Road Infrastructure Design Report

Alterations to Shoreline GA01 Lands at Baldoye

Stapolin Growth Area 1, Baldoye, Co. Dublin

BS 1192 FIELD **BD-CSC-ZZ-XX-RP-C-0107-P3**

4.1 Issue:

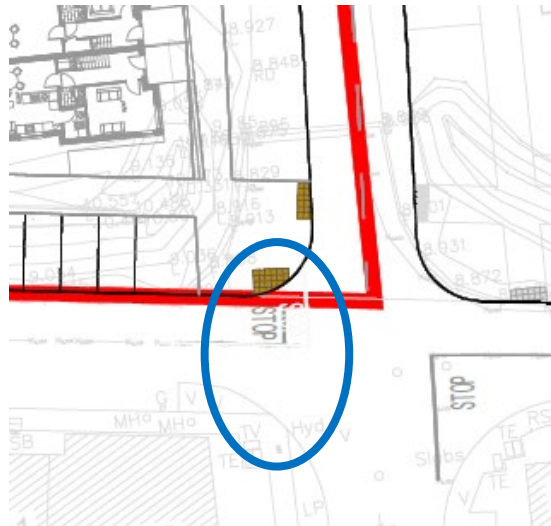
Dropped kerbs and tactile paving are proposed on the northwest quadrant of the Myrtle Avenue / Longfield Road crossroads. However, no dropped kerbs or tactile paving is provided at the crossing point on the southern footpath. A lack of adequate dropped kerbs and tactile paving may lead to difficulties for visually impaired pedestrians crossing at this location.

Provide dropped kerbs and tactile paving on the southern footpath.

4.2 Issue:

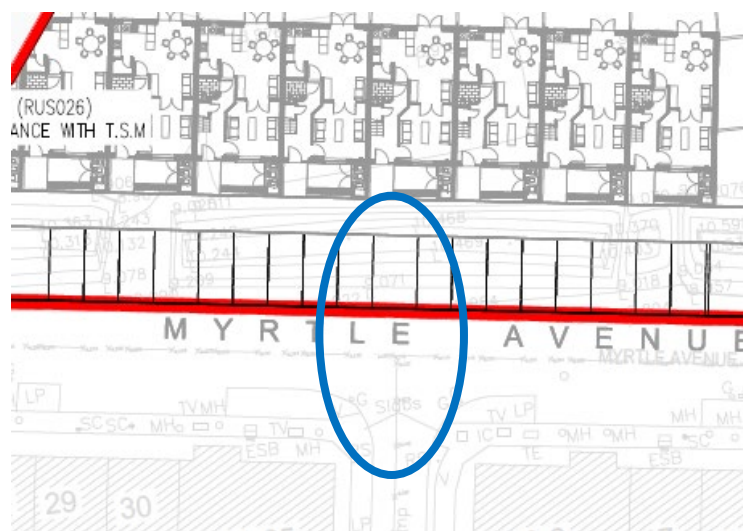
There are no pedestrian crossing facilities provided along Myrtle Avenue to cater for pedestrians crossing between the access road to the south of Myrtle Avenue and the proposed development to the north. A lack of an adequate pedestrian crossing may contribute to a pedestrian collision at this location.

Provide a pedestrian crossing facility across Myrtle Avenue at this location.

4.3 Issue:

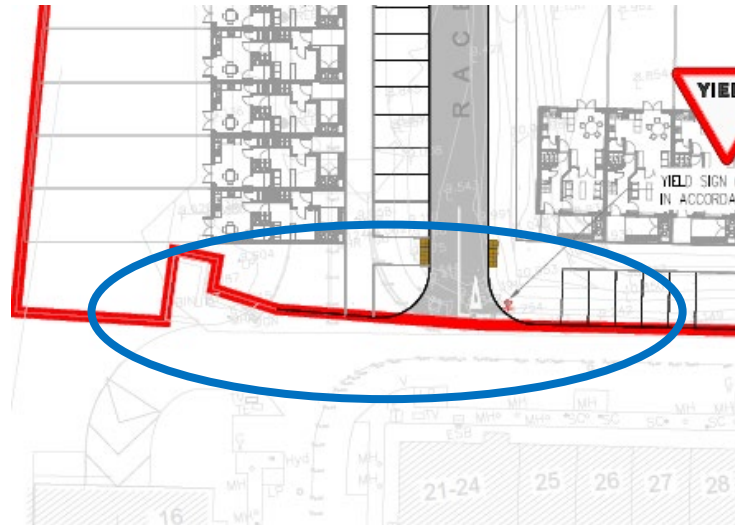
Visibility splays from Racecourse Road onto Myrtle Avenue may be restricted by the proposed parking to the east of the junction. In addition, forward visibility for a driver turning right from Myrtle Avenue onto Racecourse Close may be obstructed by the buildings on the inside of the bend on the southern side of Myrtle Avenue. A lack of adequate visibility may contribute to a turning collision at this location.

4.4 Issue:

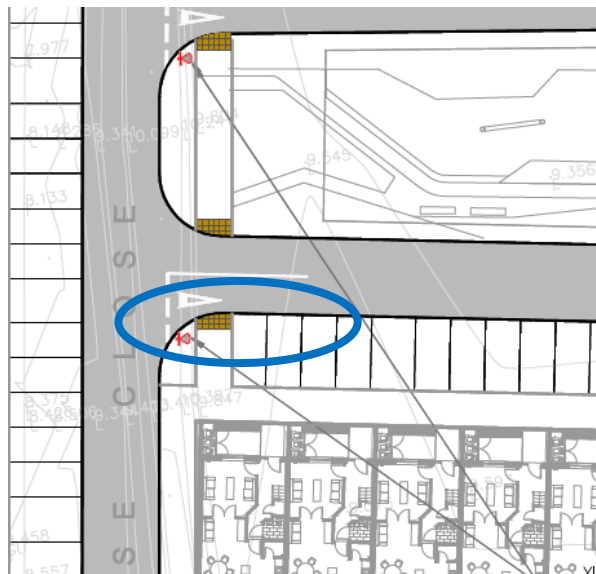
There are no pedestrian crossing facilities provided at the proposed junction of Racecourse Road with Myrtle Avenue to cater for pedestrians accessing the existing footpath located on the south side of Myrtle Avenue. A lack of an adequate pedestrian crossing may contribute to a pedestrian collision at this location.

Provide dropped kerbs and tactile paving on the southern footpath.

4.6 Issue:

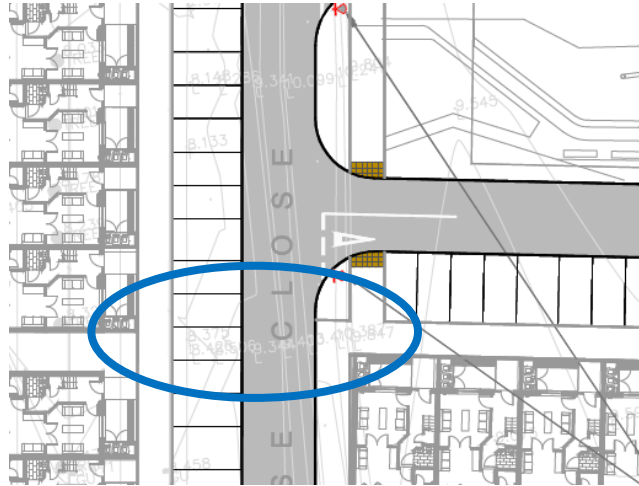
There are no pedestrian crossing facilities provided to cater for pedestrians accessing the proposed footpath on the western side of Racecourse Close from the proposed footpath on Racecourse Lane Avenue. A lack of an adequate pedestrian crossing may contribute to a pedestrian collision at this location.

Provide pedestrian crossing facilities to cater for the desired route for pedestrians.

4.7 Issue:

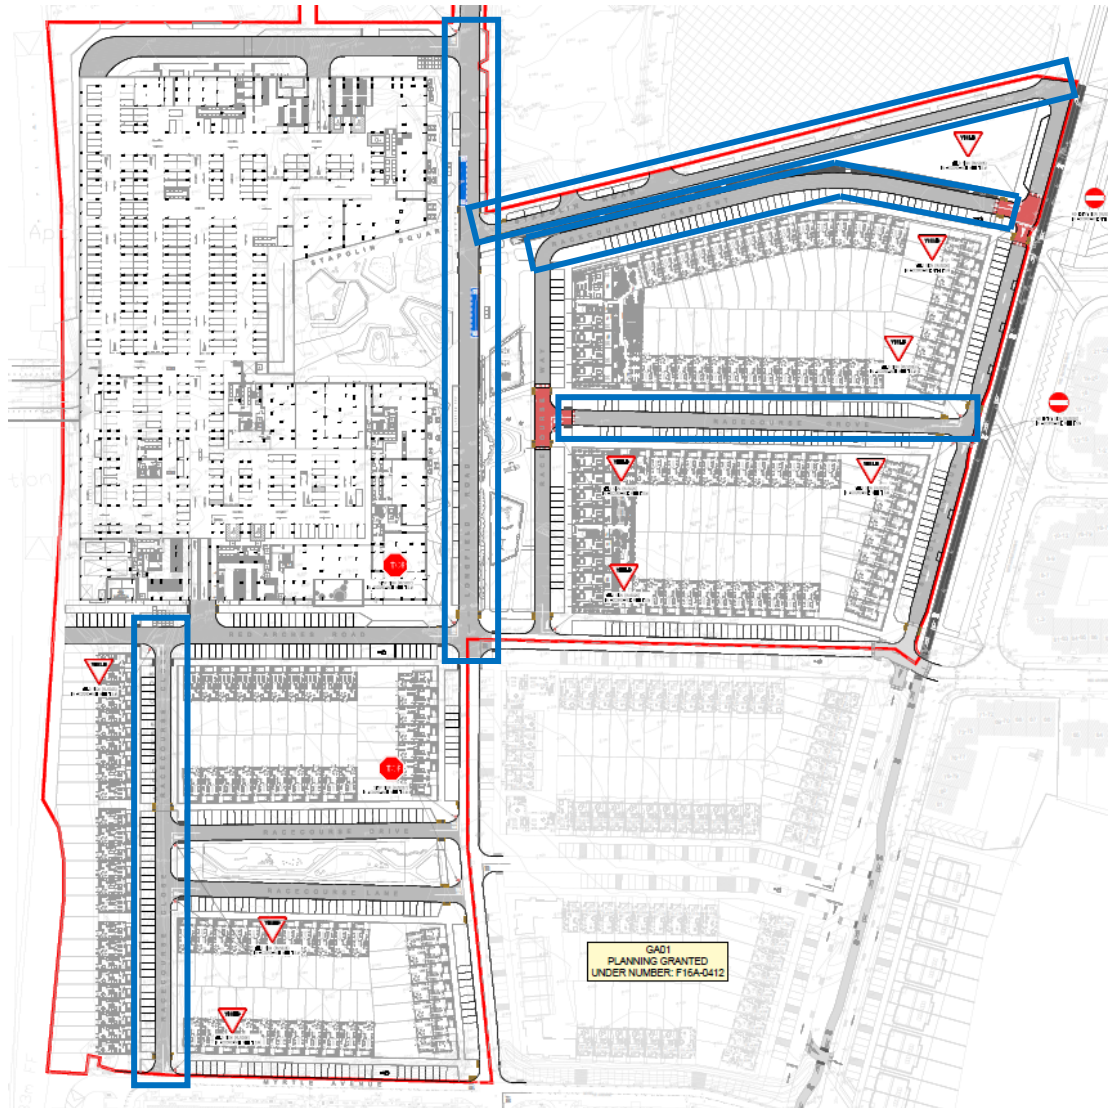
A number of the internal access roads within the proposed development are relatively long and straight. This may encourage high speeds on these sections of road which may increase collision risk.

Provide speed reduction measures along these sections of road.

4.8 Issue:

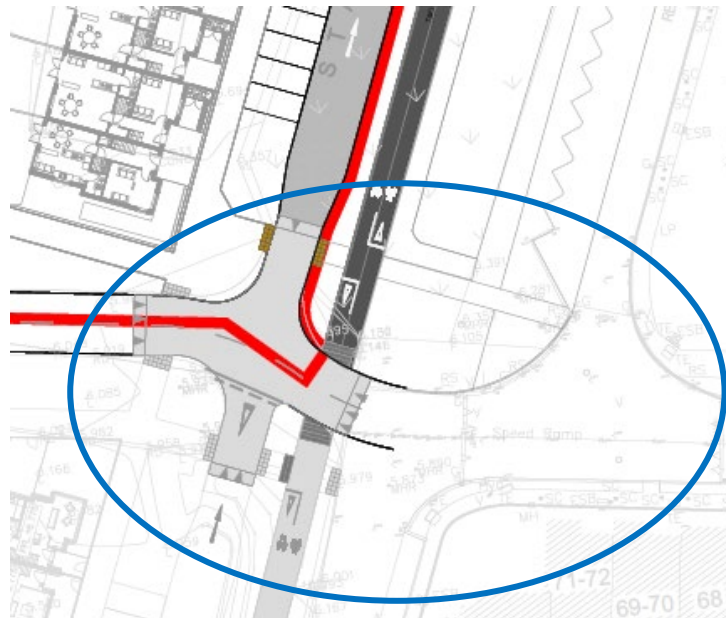
There are no pedestrian crossing facilities provided to cater for pedestrians accessing the proposed footpath on the northern side of Red Archers Road from the proposed footpath on the east side of Racecourse Close. A lack of an adequate pedestrian crossing may contribute to a pedestrian collision at this location.

Provide pedestrian crossing facilities to cater for the desired route for pedestrians.

4.10 Issue:

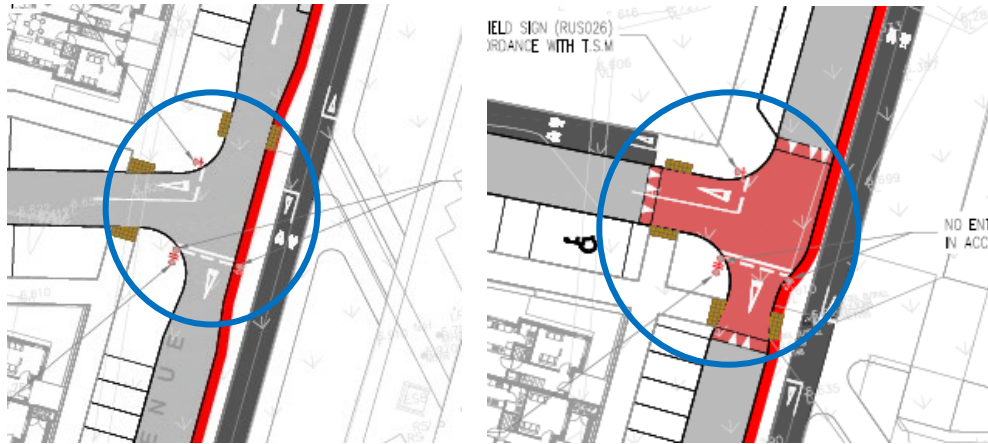
Yield markings are proposed on two arms of the Stapolin Avenue / Racecourse Grove junction and Stapolin Avenue / Racecourse Crescent junctions. Priority at these junctions is unclear and may cause confusion for drivers which may lead to a collision at these locations.

Remove the yield markings on Stapolin Avenue.

4.11 Issue:

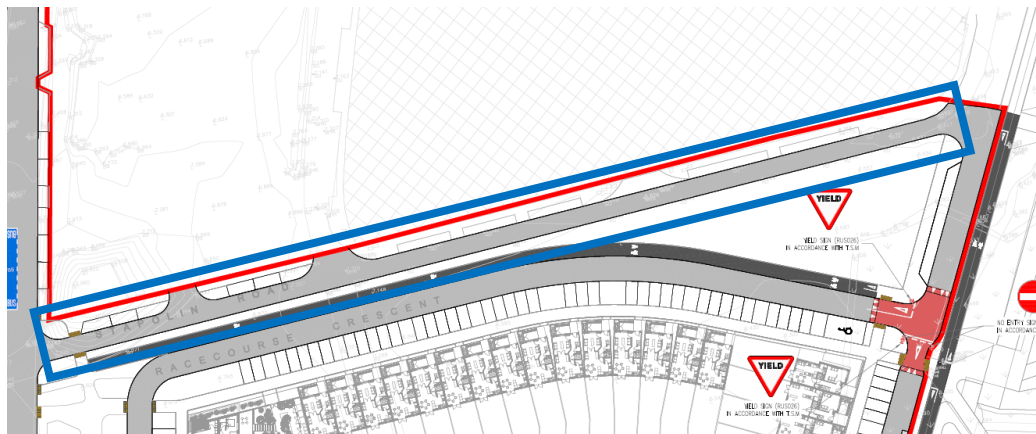
It is assumed that the section of Stapolin Avenue to the north of its junction with Racecourse Crescent is one-way northbound while Stapolin Road is one-way westbound. However, signage or road markings are not shown to be provided to reflect this.

Provide adequate signage and road markings to enforce the one-way system. If a two-way system is proposed ensure that adequate carriageway width is provided to cater for two-way traffic.

4.12 Issue:

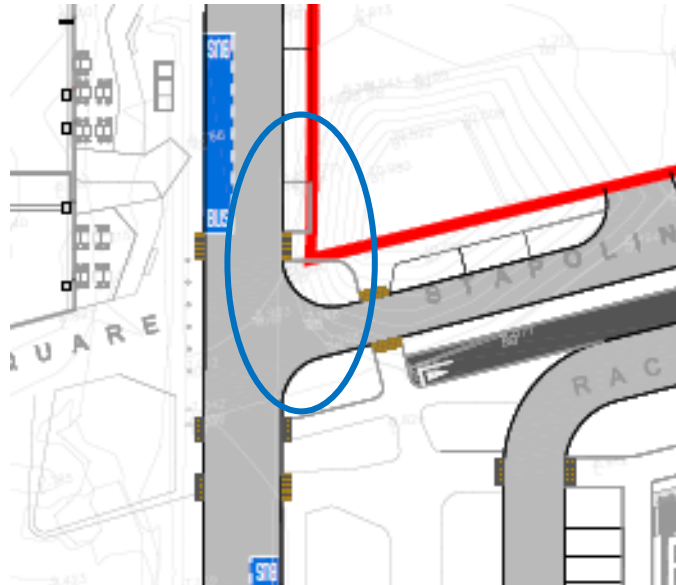
Visibility splays at the proposed access from Stapolin Road onto Longfield Road may be restricted by the proposed parking to the north of the access. In addition, no junction control is provided on Stapolin Road and priority at the junction may be unclear.

Ensure adequate visibility splays in accordance with section 4.4.5 of the DMURS are provided. Provide adequate junction control to clearly define vehicular priority at the junction.

4.13 Issue:

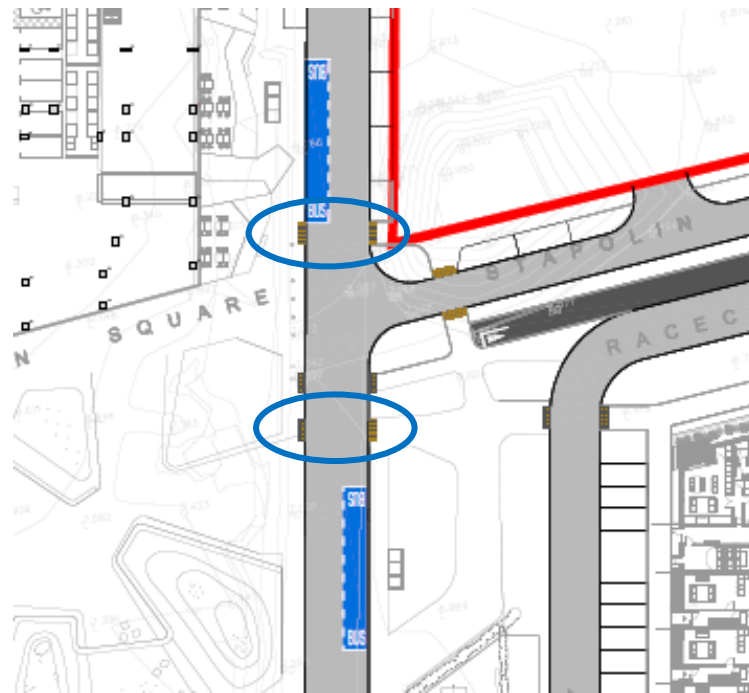
Two-number on-street bus parking bays are provided along Longfield Road. Pedestrian crossings are proposed adjacent to the bus stops. Inter-visibility between drivers of vehicles approaching the pedestrian crossing along Longfield Road and a pedestrian stopped waiting to cross at the pedestrian crossings may be obstructed when a bus is stopped at the bus stop. A lack of adequate inter-visibility may contribute to a pedestrian collision at these locations.

Move the on-street bus stops or relocate the pedestrian crossings to ensure visibility splays are provided.

4.14 Issue:

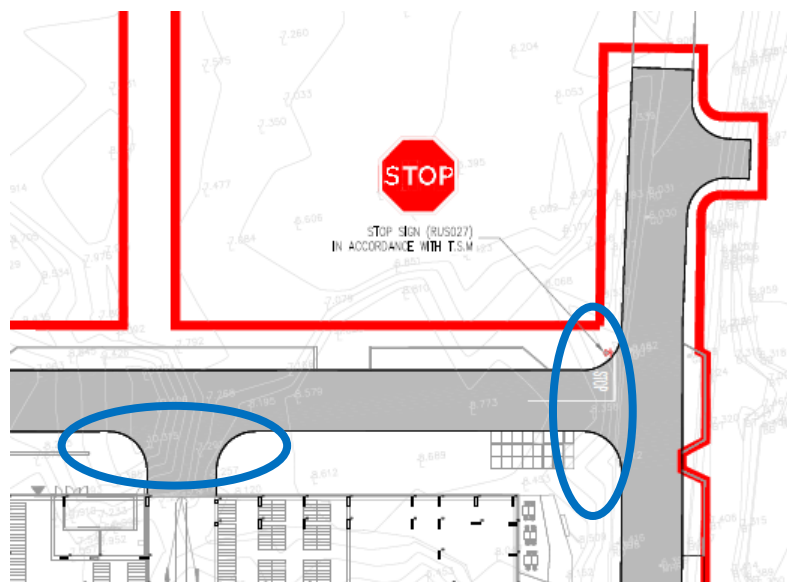
There are no pedestrian crossing facilities provided to cater for pedestrians crossing the Bus Route arm of its junction with Longfield Road and crossing the proposed access to the underground car park. A lack of an adequate pedestrian crossing may contribute to a pedestrian collision at this location.

Provide pedestrian crossing facilities to cater for the desired route for pedestrians.

4.15 Issue:

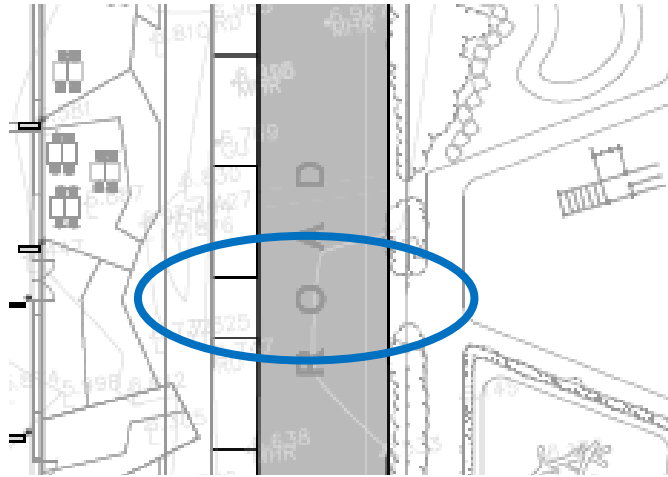
Pedestrian crossing facilities are provided along Longfield Road. However, no dropped kerbs or tactile paving is shown to be provided at the intermediate crossing point. A lack of an adequate pedestrian crossing may contribute to a pedestrian collision at this location.

Provide dropped kerbs and tactile paving at the proposed pedestrian crossing.

4.17 Issue:

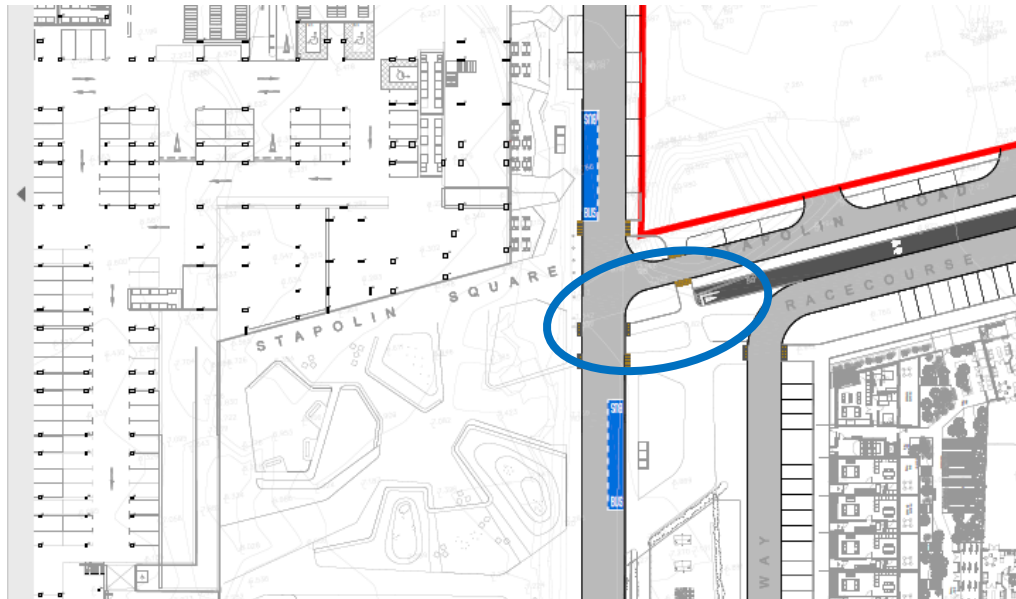
A pedestrian or cycle link is not shown to be provided from the western end of Red Arches Road to allow pedestrians and cyclists to access the existing train station from this location.

Provide a pedestrian and cycle link from the western end of Red Arches Road to the existing train station.

4.19 Issue:

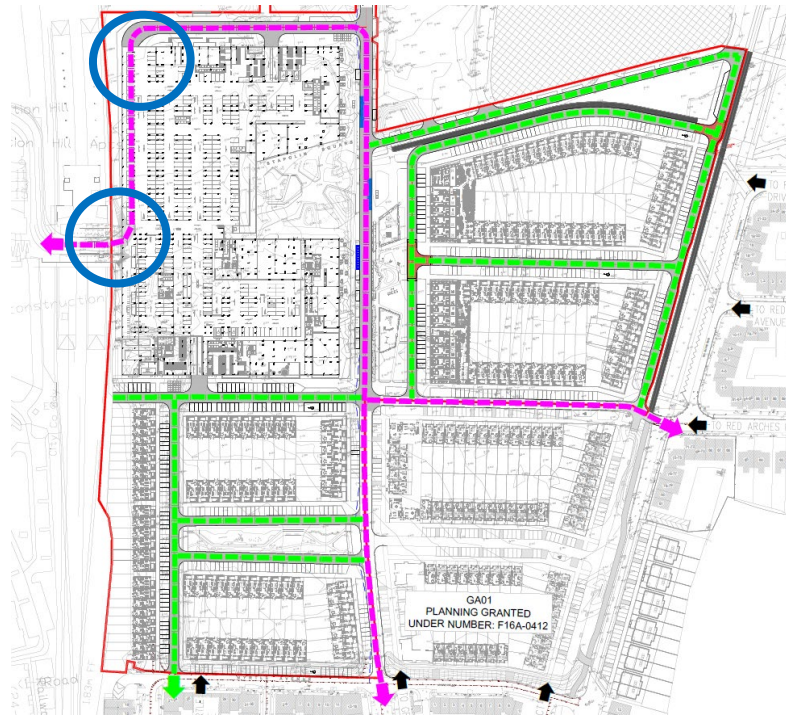
The proposed route indicated in magenta below is labelled as a link route. There are two number low radius bends along this route. It is unclear whether the geometry proposed along this link road is in accordance with the DMURS standard for link streets.

4.23 Issue:

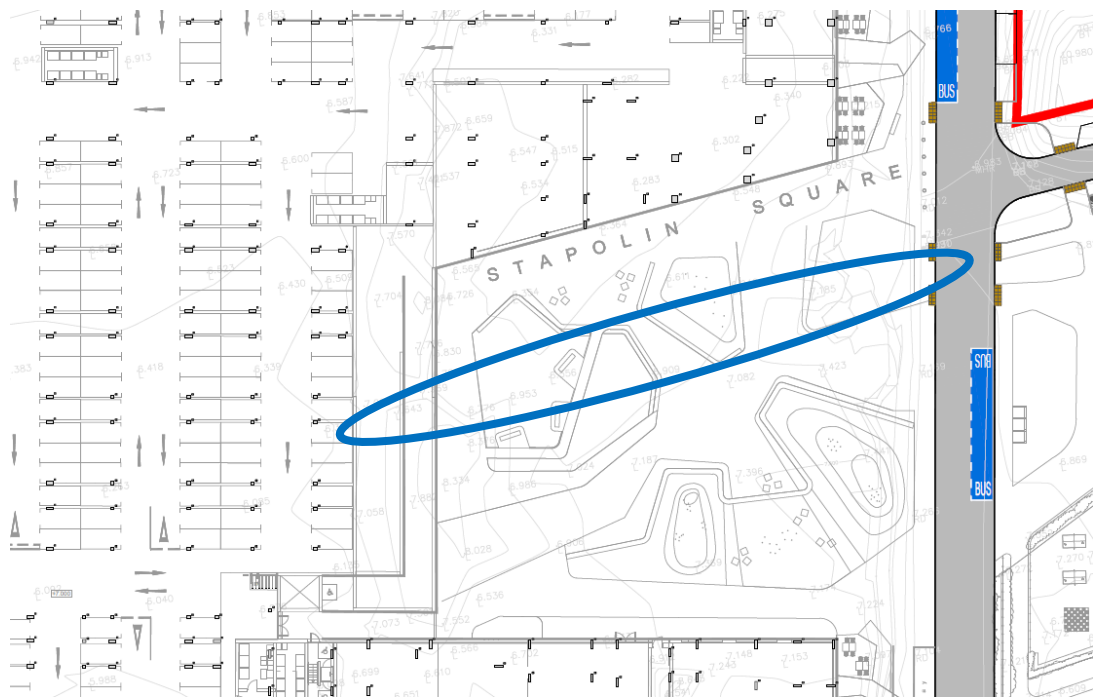
There are a number of locations within the underground car park where entry prohibition and priority at junctions are not indicated which may lead to confusion for drivers of vehicles at these locations.
